Project	IEEE 802.16 Broadband Wireless Access Working Group < http://ieee802.org/16 >	
Title	DL HARQ for non-transparent Relays	
Date Submitted	2007-05-10	
Source(s)	Junichi Suga Fujitsu Laboratories Ltd. Kamikodanaka 4-1-1, Kawasaki, 211-8588, Japan	Voice: +81-44-754-2811 Fax: +81-44-754-2786 Email : suga.junichi@jp.fujitsu.com
	Michiharu Nakamura Fujitsu Laboratories LTD 5-5, Hikarinooka Yokosuka, Japan. 239-0847	Voice: +81-46-839-5371 Fax: +81-46-839-5560 Email : michi@labs.fujitsu.com
	Haihong Zheng, Yousuf Saifullah, Shashikant Maheshwari Nokia 6000 Connection Drive, Irving, TX	Voice: 972 894 5000 Fax: haihong.1.zheng@nokia.com , shashikant.maheshwari@nokia.com , Yousuf.saifullah@nokia.com
	Aik Chindapol Yishen Sun Jimmy Chui Siemens Corporate Research Princeton, NJ, USA	Voice: +1 609 734 3364 Fax: +1 609 734 6565 Email: aik.chindapol@siemens.com
	Kyu Ha Lee Samsung Thales San 14, Nongseo-Dong, Giheung-Gu, Yongin, Gyeonggi-Do, Korea 449-712	Voice: +82-31-280-9917 Fax: +82-31-280-1562 Email: kyuha.lee@samsung.com

Downlink HARQ with Relay

Specific text changes

Figure xxx. HARQ RS Error Report Header Format

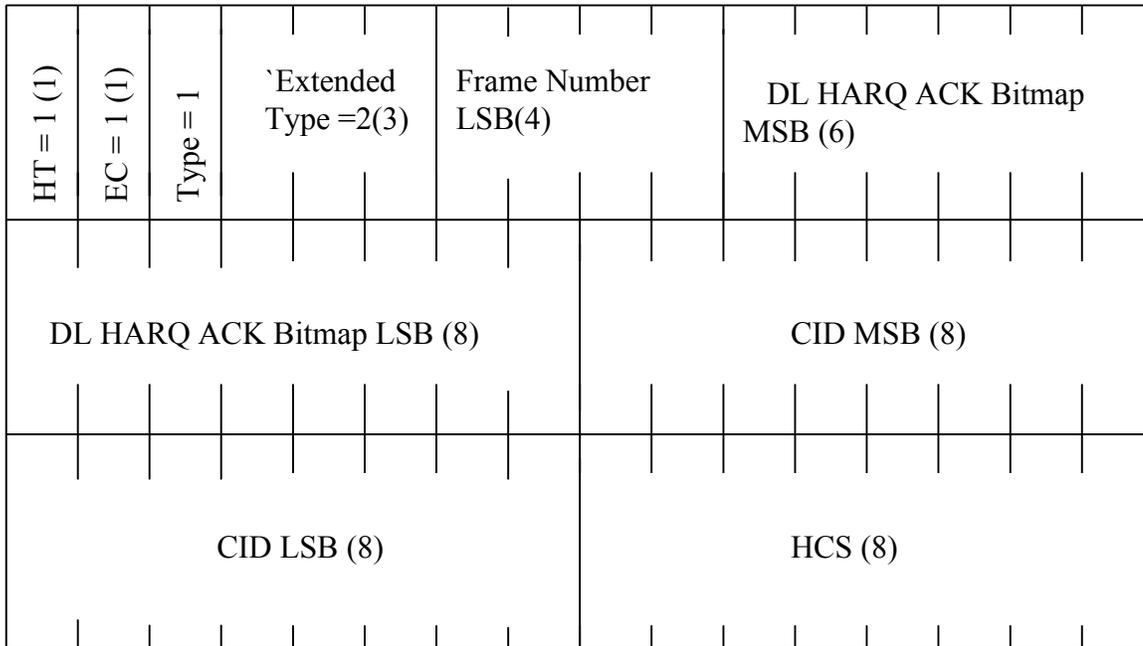
The RS HARQ Error Report header is used for RS to provide ACK/NAK when RS is unable to decode HARQ DL data successfully. The RS can send this header to MR-BS or parent RS as an unsolicited feedback in UL relay zone. The header format is illustrated in Figure xxx.
